Minutes of 13th Meeting of Technical Advisory Group of Ken-Betwa Link Project Authority held on 13.08.2025 in online mode

13.1 Agenda Point -1: Review of the Alternate alignment (Tunnel + Canal Combination) of Ken-Betwa Link Canal from R.D. 116150 m to R.D. 125622 m in village Ramnagar as proposed in 11th TAG.

**PROPOSAL FOR THE
TECHNICAL ADVISORY GROUP
FOR
TUNNEL BETWEEN RD 116.1 KM
AND RD 125.7 KM OF
KEN-BETWA LINK CANAL**

Examination of note on techno-economic comparison of constructing a tunnel section for the Ken-Betwa Link Canal between RD 116.1 km and RD 125.7 km instead of proposed open channel submitted by KBLPA

Map showing original and revised alignment with the tunnel

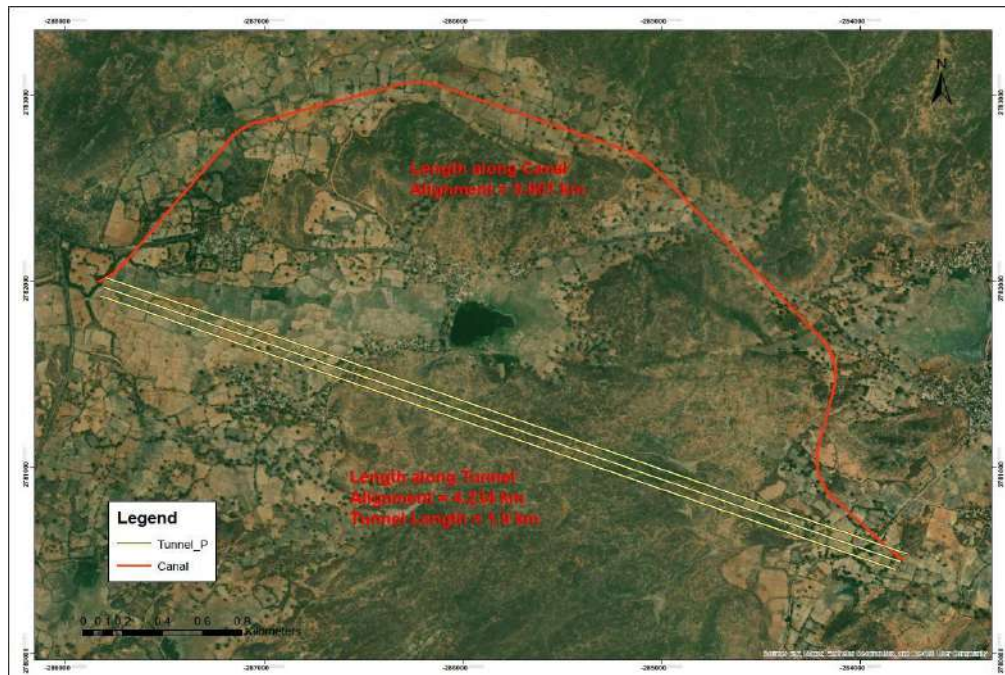
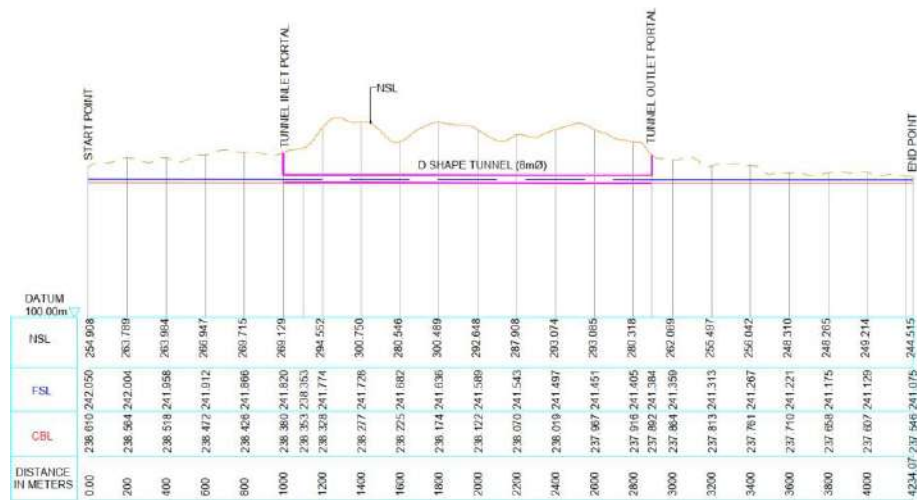
This has reference to the MOM of the 11th TAG meeting held on 9&10 May 2025 wherein the technical review of the proposed modified alignment of KBLC was carried out by TAG of the KBLPA. The TAG agreed to the proposal of Govt of MP for all the reaches except for RD 116150m to 125622m (village Ramnagar). The two alternatives presented for this reach discussed in the TAG were (1) Canal: 5.89 km and (2) Tunnel: 1.5 km + Canal :2.75km.

“The TAG noted that alignment proposed has multiple sharp bends and involves an additional length of 603 meters. The TAG also noted that there could be a straight route between coordinates E- 323029.938 N-2759607.085 and E- 319454.246 N- 2760476.974, which would reduce the length of alternate alignment significantly. However, this route involves tunnel in around 1.5 km reach which may be feasible. In the light of this, the TAG suggested that the option of taking water through the tunnel/canal combination to the extent feasible may be explored between coordinates E-323029.938 N- 2759607.085 and E-319454.246 N- 2760476.974. This will reduce the length and minimize the bends in the water carrier, reduce the losses and thus will be more efficient.”

- (i) With constraints of parameters such as fixed discharge (76.23 cumec), predetermined tunnel entry and exit points (slope of tunnel), the need to match the gradient of the tunnel with that of the canal, it is hydraulically feasible to convey the required discharge only either through a single large-sized tunnel or through twin smaller-sized tunnels. However, both these options shall be cost-intensive and time-consuming from a construction perspective.
- (ii) It is also mentioned in the note that the CEO (KBLPA), ACEO (Canal) and officers from the WRD, GoMP and KBLPA officials visited the site to evaluate the feasibility of construction of tunnel near Ramnagar/Charee village in Tikamgarh District. The team after inspection of the site observed and indicated potential technical and financial challenges associated with choosing tunnel construction in place of open canal.

1) In the Technical Specifications and Desktop Study Results it is mentioned, *"The flow operation in the tunnel requires a steeper gradient and significant hydraulic head compared to the canal. However, since the inlet and outlet levels are fixed, the required hydraulic head is not available. Therefore, construction of the tunnel in this reach may not be feasible."*

As per my understanding, by maintaining the slope envisaged in the original alignment for the open channel in the 1st alternative (open channel plus tunnel) which is 1,600 m shorter than the 2nd alternative (open channel only), the gradient saved in the shortened length can be transferred to the tunnel portion, allowing it to be made steeper. So, this point needs consideration.

10. All the members preferred the original open canal alignment over the earlier proposed combination of tunnel & canal alignment.
11. Finally, the Chairman, TAG-KBLPA accepted the recommendation of the members for adopting the open canal and advised that further action be taken accordingly.

Therefore, in view of the above it is opined that the TAG may consider and opt for the open channel alternative-1 considering the advantages of open canal and constraints in hydraulic design of the tunnel in the instant case.

L-SECTION OF TUNNEL

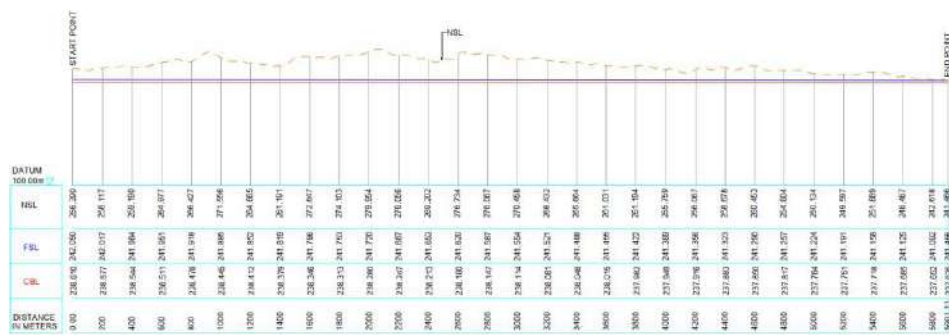
- iv. The flow operation in tunnel requires a steeper gradient and significant hydraulic head compared to the canal. However, since the inlet and outlet levels are fixed, the required hydraulic head is not available. Therefore, construction of the tunnel in this reach may not be feasible.

- v. To prevent silt deposition issues, the tunnel flow depth has been considered limited to 3.44 meters, matching the canal's design depth. This constraint necessitates a tunnel bed width of 15.50 meters. However, constructing a single tunnel of 15.50 meters diameter presents significant technical challenges and may not be practically feasible.

- vi. Consequently, the study evaluated twin tunnel configuration with 8-meter diameter specifications may be considered as an alternative. This approach would provide equivalent hydraulic capacity while utilizing more conventional tunneling methodologies and equipment.

L-Section of Ken River from Banda Barrage Axis towards U/s.

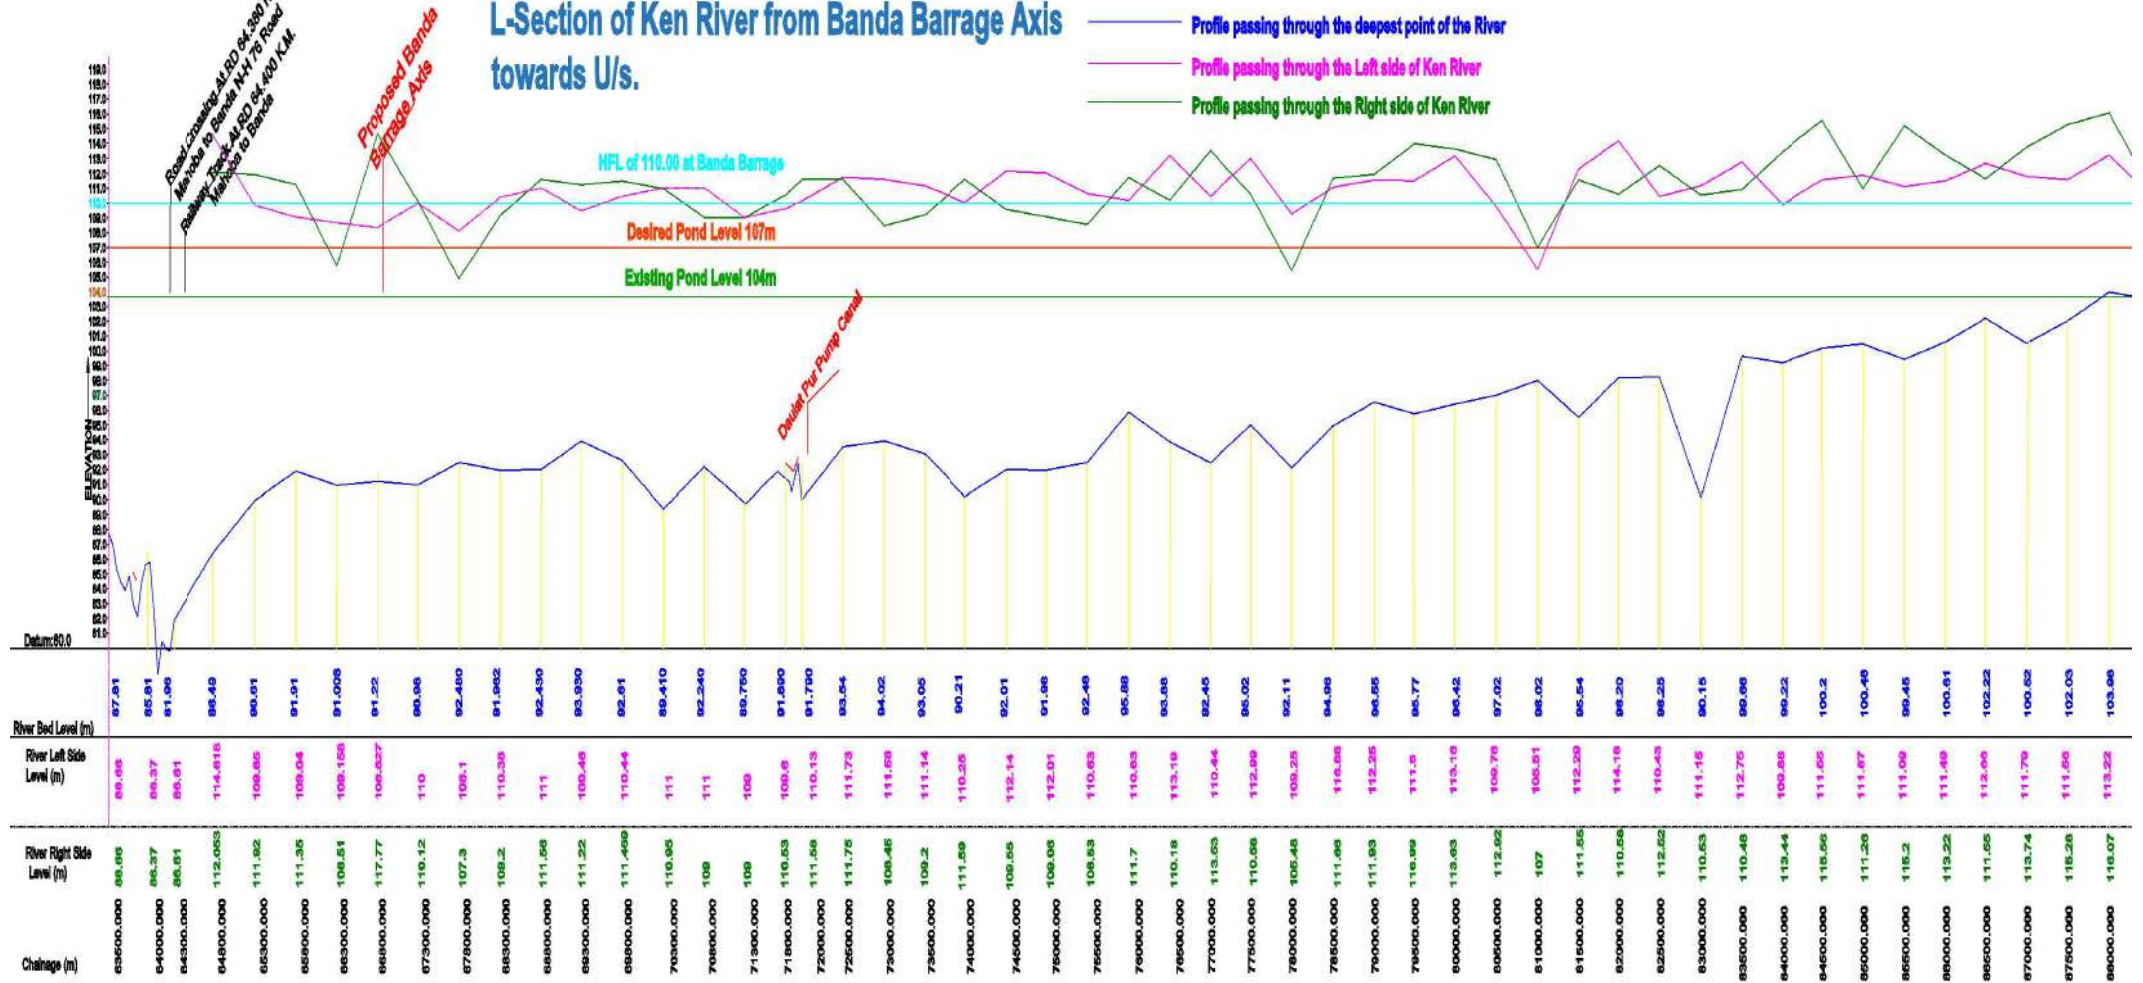
4. Shri Vijai Saran, Member TAG, suggested that study to determine the backwater levels at the various ponds level should be taken up to determine the extent of the fetch and submergence area using HEC-RAS.

- The backwater study for different pond levels shall be undertaken using the HEC-RAS software.
